PROJECT: Gilcrease Nature Sanctuary

SUBJECT: Drainage Study for:

Gilcrease Nature Sanctuary

**DISTRICT CONCURRENCE: GILCREASE NATURE SANCTUARY
(DS 4541A) (RFCD No. 12-8044)**

SHEET NO.
C2
4 OF 8

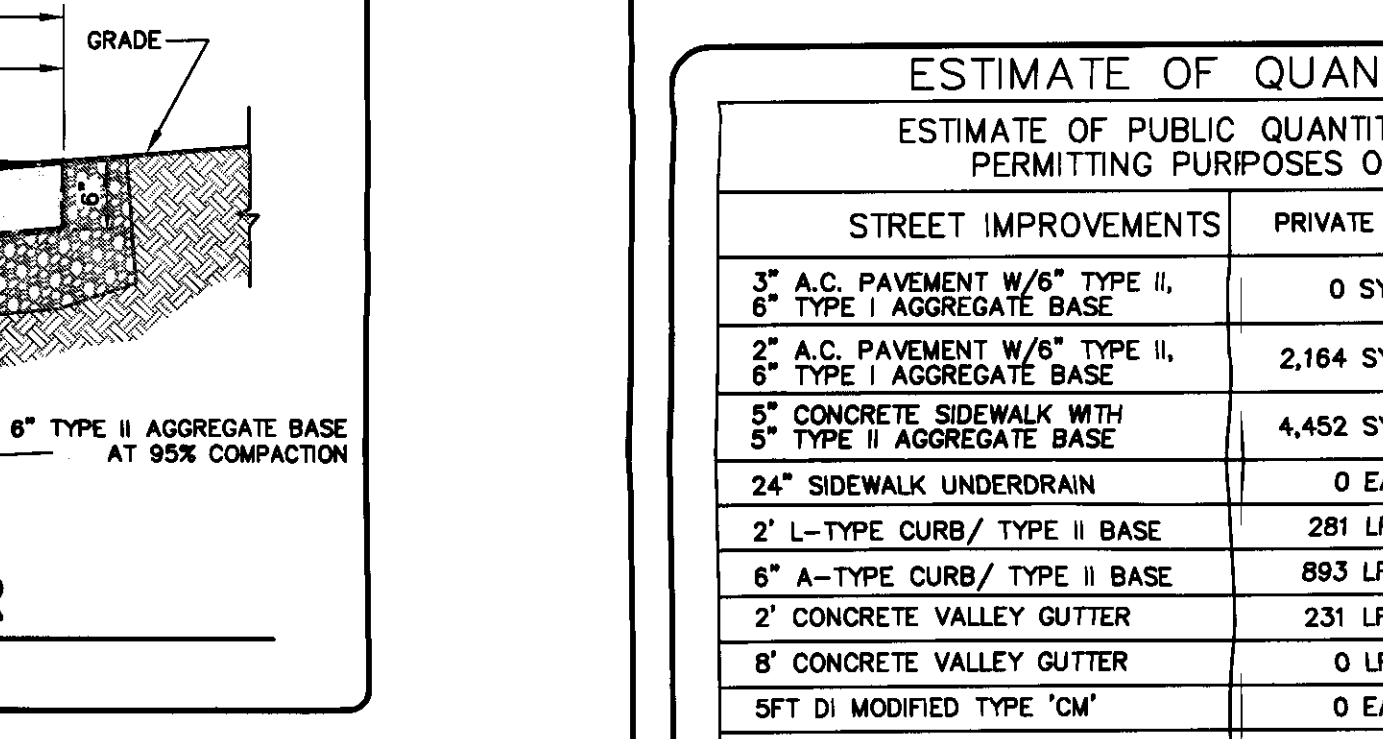
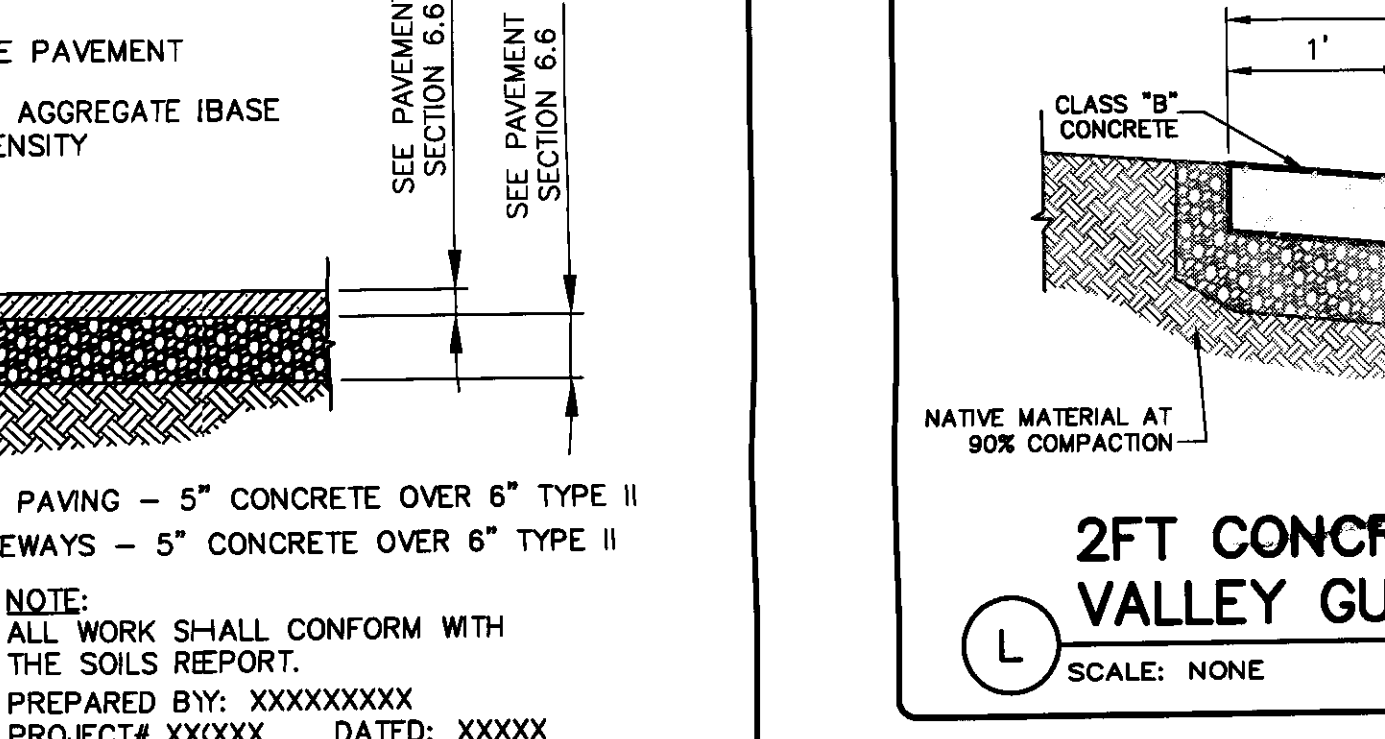
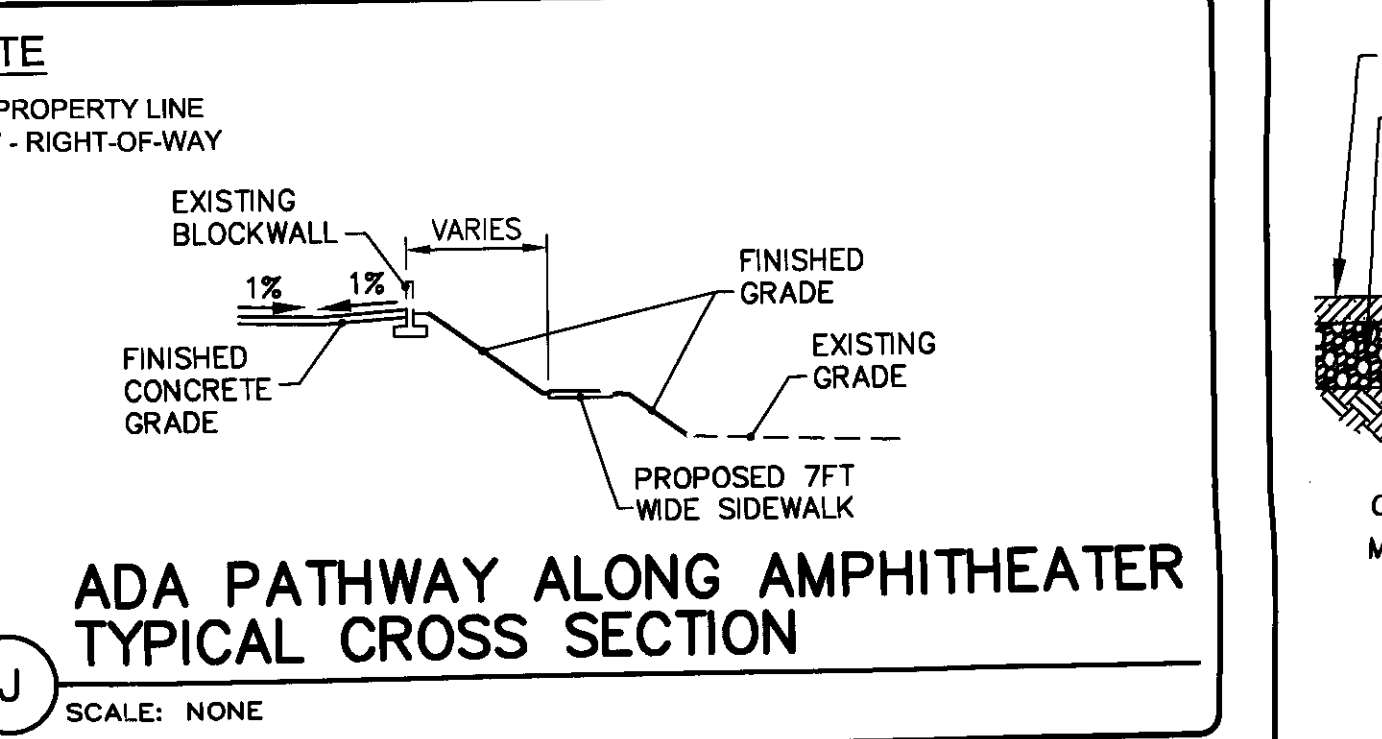
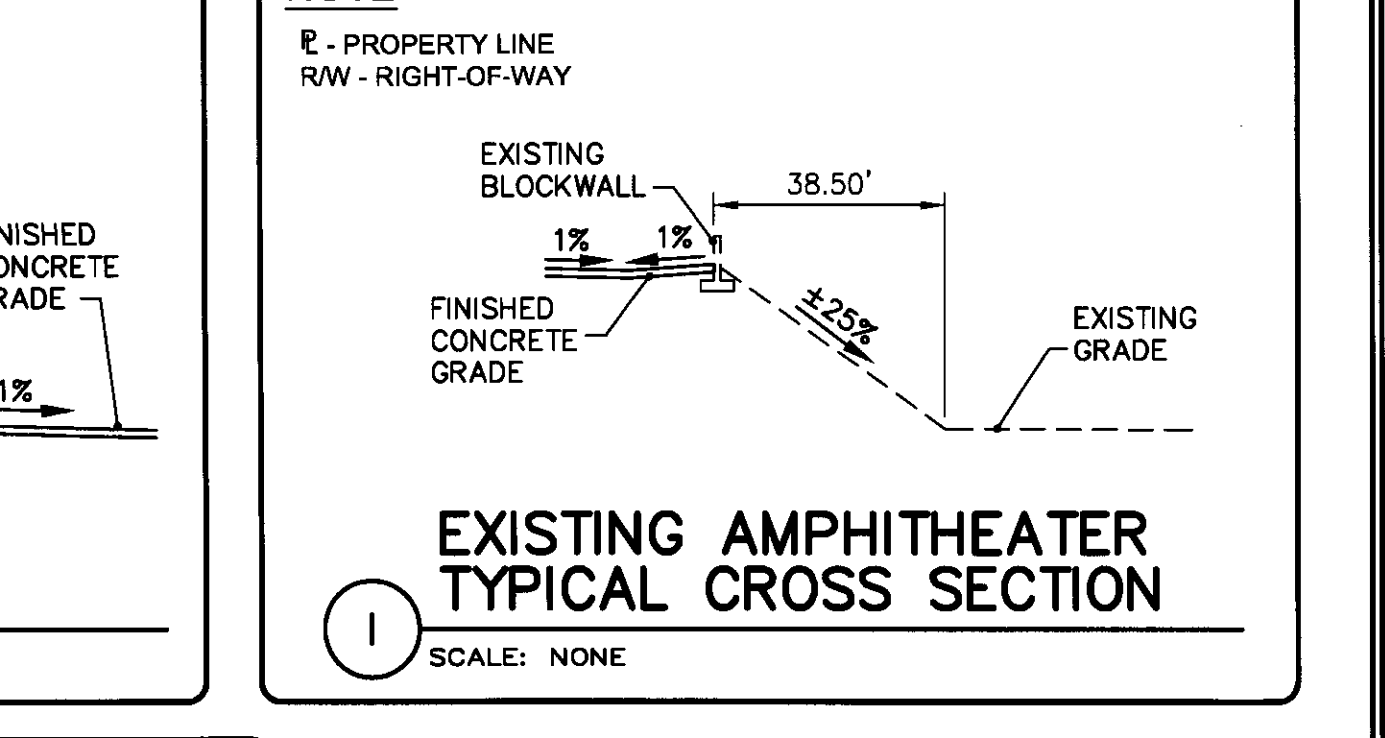
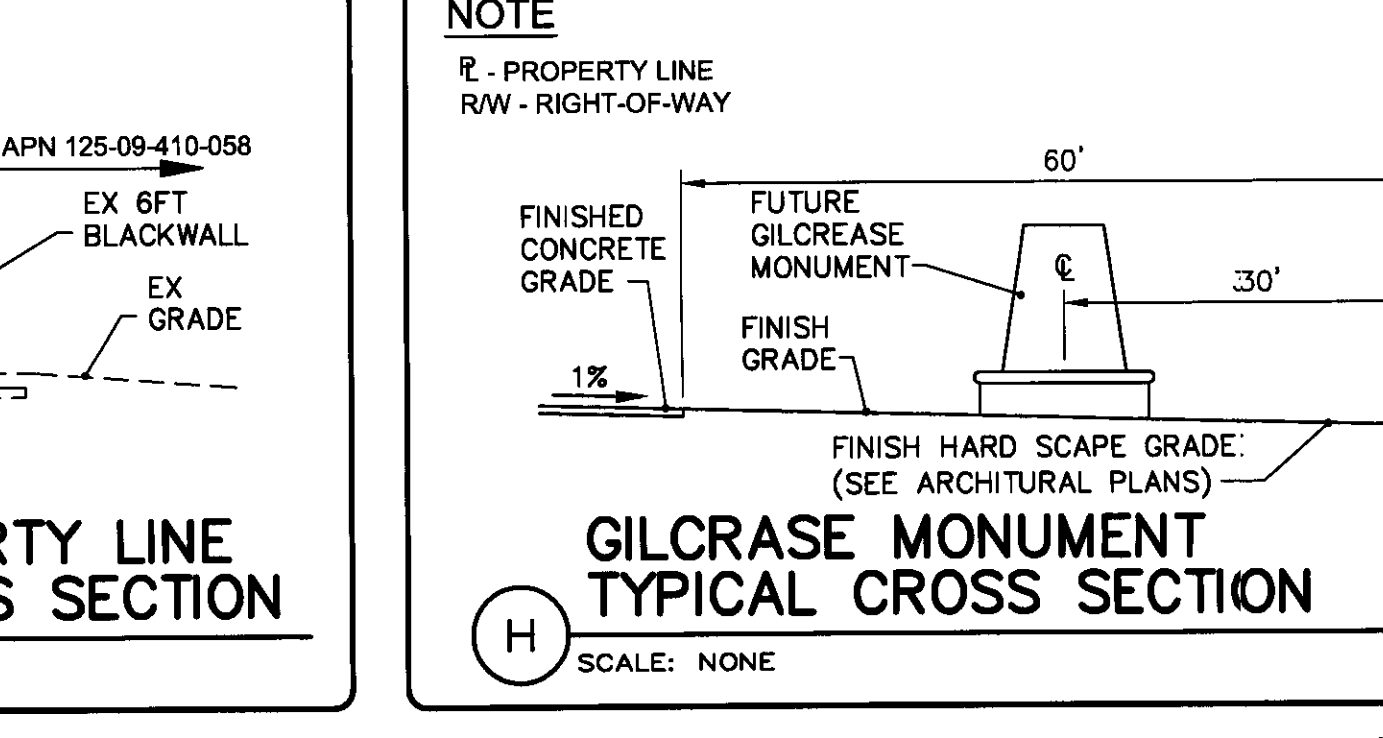
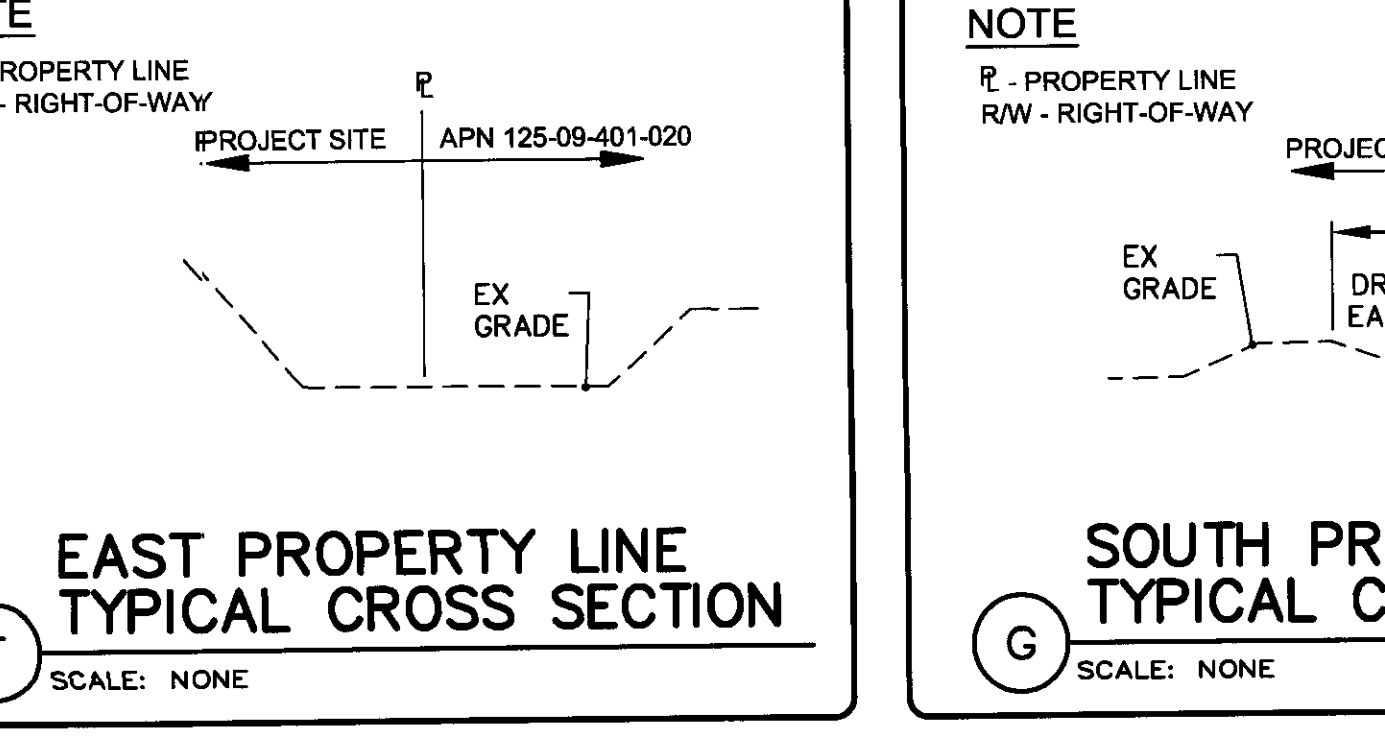
District has the following comment(s): Sta: 21+32.41: Provide a structural connection detail for the proposed 18-inch storm drain lateral to the existing manhole.

This supplement to the Technical Drainage Study for Gilcrease Nature Sanctuary is provided in response to the Clark County Regional Flood Control District request for Structural Details of the Storm Drain lateral connection to the existing Storm Drain in Racel Street. A note has been added to Detail O on Sheet C2 calling out Detail P on the same sheet. Detail P has been added to sheet C2 detailing the structural connection between the proposed 18" storm drain lateral and the existing storm drain junction box in Racel Street. Structural calculations are not necessary for this design.
